RS-05-070

Subject: Response to Request for Additional Information Regarding the Byron Station, Unit 1, Loop Stop Isolation Valve

Attachment 2: Plant Issue Resolution Documentation #2005-02, Revision 1

Response to NRC Request for Additional Information (RAI)
Regarding the Byron Station, Unit 1
Loop Stop Isolation Valve, 1C
(Equipment Tag 1RC8002C)

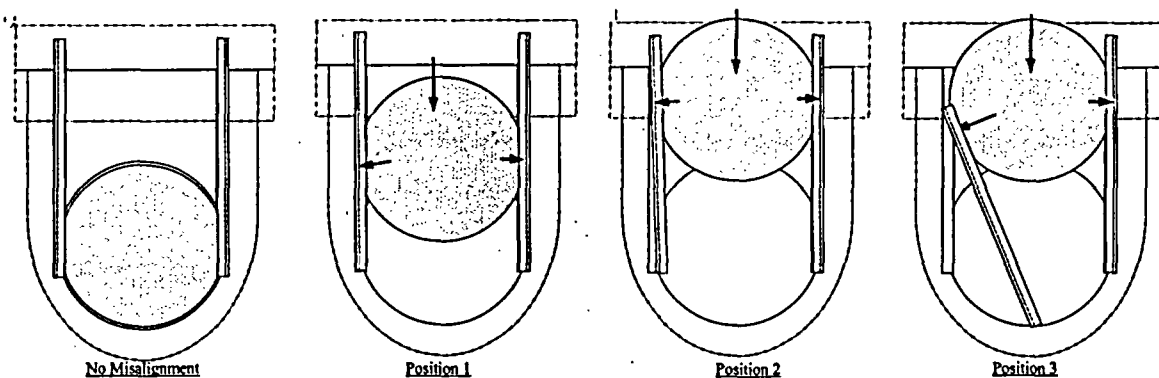
Please provide material properties of the valve guides and related information that demonstrate their capability to maintain structural integrity under the load exerted by the 1RC8002C motor actuator during a worst-case misalignment orientation.

No formal calculations have been performed in evaluating the guide integrity; however, using a very simplified approach, three misalignment positions (as illustrated below) were considered for the guide to evaluate the potential for significant damage up to and including fracture. The results of these three cases are based on standard equations used in determining moments of inertia, bending moments and total stresses in the mispositioned guide.

The guide is fabricated from hardened stainless steel (i.e., American Iron and Steel Institute A 410 specification) with a minimum specified yield strength of 140 ksi and an ultimate strength of 165 ksi. Based on the current configuration of loop stop isolation valve, 1RC8002C, the maximum output of the Limitorque motor operated valve actuator is approximately 75,000 lbs stem thrust based on the measured motor current at the torque switch trip setpoint. It has been concluded that it will require greater than 100,000 lbs force to cause deformation during a worst-case misalignment orientation resulting from the valve guide resting at the bottom of the valve. Even under these conditions, structural integrity of the valve guide is maintained.

For position 1, the guide is postulated to be slightly out of alignment. The thrust force required to yield the guide was calculated assuming this guide takes 100% of the thrust force generated by the valve operator. Considering the guide as a simple beam supported at its ends, the normal force (i.e., perpendicular to the guide) required to yield the guide is 11,700 lbs. At one degree, this corresponds to a vertical thrust force greater than 600,000 lbs. The deflection of the guide was also calculated at the mid-height based on the load required to yield the guide. The calculated deflection at the mid-height is approximately 1/2-inch, which is greater than the offset of the guide; thus, the guide would deflect into the retaining groove in the valve body resulting in additional support of the guide before it could reach the yield limit of the guide material.

In position 2, the guide is postulated to be at the edge of the guide support shelf (i.e., angle of the guide at approximately four degrees). The normal force was recalculated assuming the disk contact point was at 1/4 of the guide length (L/4). The force required to yield the guide is 15,700 lbs. This corresponds to a full thrust force of 225,000 lbs.

Position 3 considered the valve guide at the bottom of the valve body with 20 degree misalignment plus 10 degree misalignment in the direction of the flow. This configuration will result in biaxial bending of the guide. At this location the disk makes contact with the guide at approximately 1/10 its length. The thrust force acting on the guide required to cause yielding of the guide under these conditions is approximately 85,000 lbs. Considering the thrust is also resisted by the other guide from friction caused by the lateral shifting of the disk due to misalignment of the opposite guide, the total thrust required to cause deformation will be much greater, i.e., in the 100,000 to 150,000 lb range.
